# **MONITORING YEAR 1 ANNUAL REPORT FINAL**

## **DYNAMITE CREEK MITIGATION SITE**

Subject: DMS Comments on Dynamite Creek Mitigation Site Monitoring Year 1 Report  
DMS Project Number 100125, DMS Contract 7911

## Soil Temperature Probe Plot

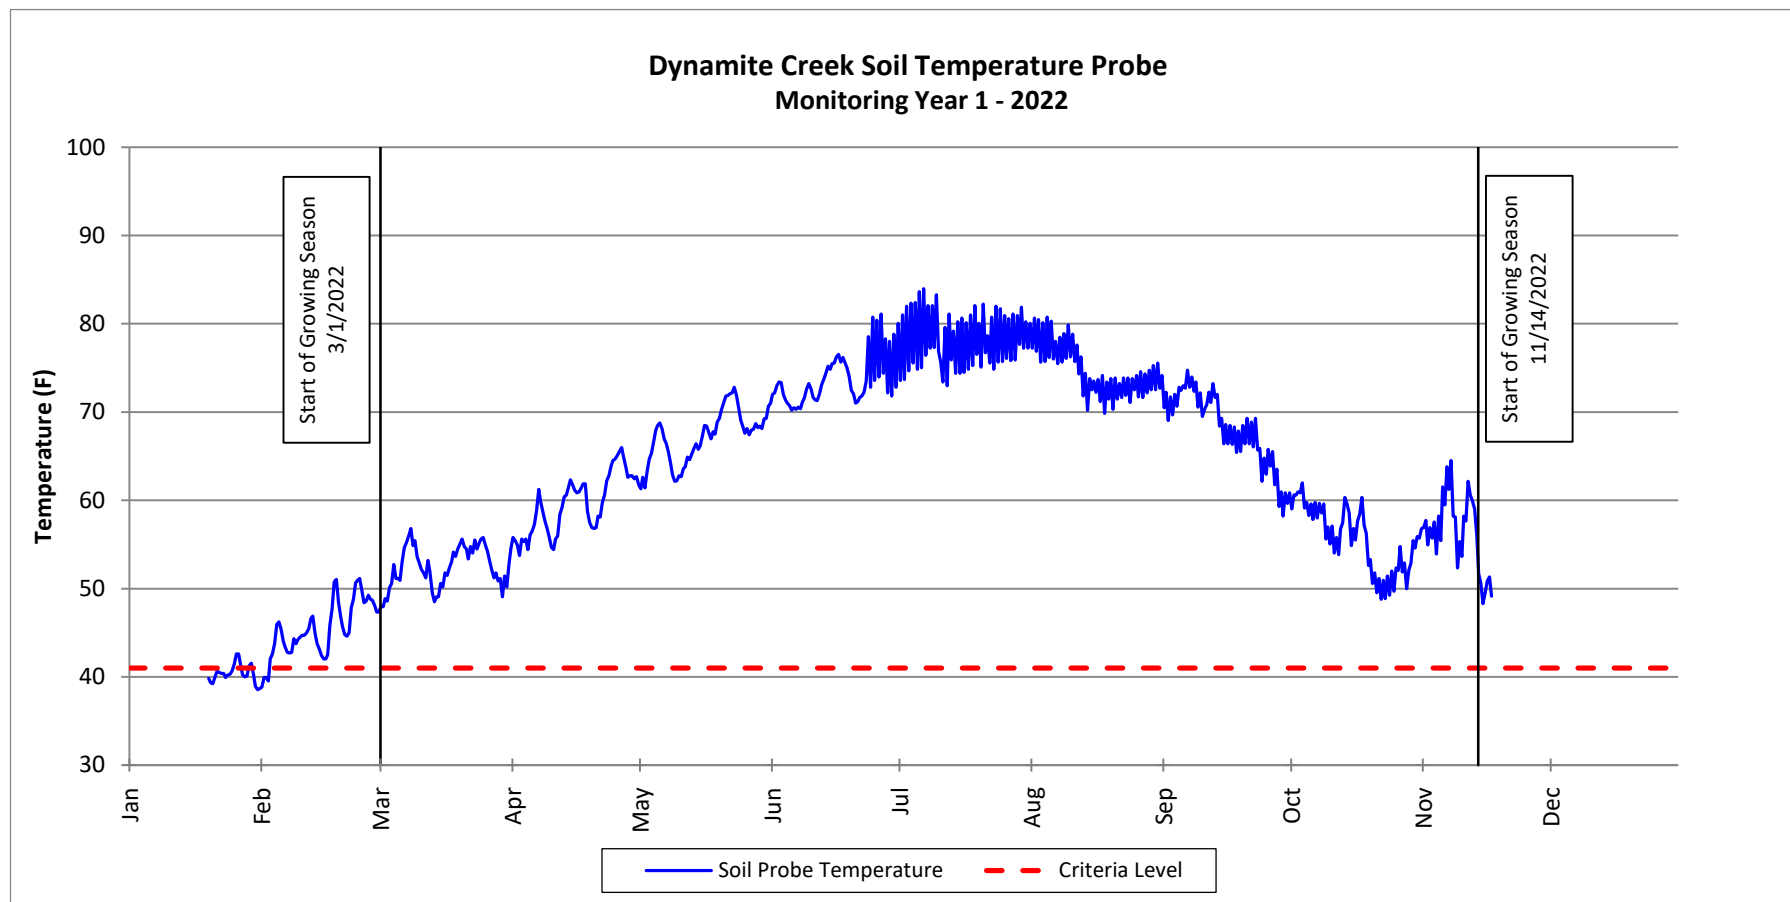
1. Section 2.6 defines the start of the growing season to be determined by soil temperature and bud burst, and the end by the Applied Climate Information Website (which is simply the most historically recent WETS). Recent correspondence with the IRT has indicated that if temperature and vegetation indicators are used to start the growing season, the same indicators must be used to determine the end. Additionally, the IRT has expressed a preference that growing season dates should be "set" at mit plan or MY1 and should not change for the remainder of project monitoring.

The hydroperiod determination is not well fleshed out in the mitigation plan stating only that "Per IRT guidance, growing dates may be modified during the monitoring period using soil temperature data and observation of bud burst. Modification of growing season dates would result in a different number of consecutive days required to achieve success..."

Since veg/temp data cannot be used to determine the end date to the MY1 growing season at this juncture, DMS recommends requesting that the IRT allow March 1 – Nov. 14 be the set growing season for the remainder of the project.

*For monitoring year 1 soil temperature data and bud burst were used to determine the start of the growing season. Based on conversations with the IRT leaf senescence data was collected to determine the end of the growing season. The onset of leaf senescence is typically agreed to be signaled by the loss of canopy greenness, which includes both leaf color change and leaf drop (Vitasse et al., 2009), which are two of the most widely used methods for determining leaf senescence dates for tree communities globally (Gill et al., 2015). Visual observations of these physical changes provide simplicity that other methods (e.g. leaf nutrient content analysis, chlorophyll degradation), which require intensive sample collection and processing, lack (Mariën et al., 2019). Wildlands chose to*

*use the 50% color change method for its simple field application and its shorter lag period between the time when leaf senescence actually starts and the physical change becomes apparent as compared to leaf drop (Mariën et al., 2019). Based on this data the end of the growing season at Dynamite Creek would be mid-October. This is further supported by the meta-analysis conducted by Gill et al. (2015) that found that in lower latitude regions, including North Carolina, temperatures in October largely control when leaf senescence starts. However, Wildlands believes that the IRT will not accept this early of a date as the end of the growing season and proposes using November 14th based off WETS Tables. To reinforce this date, soil temperature data did not drop below the forty one degree threshold before the final groundwater gauge download on November 17th.*
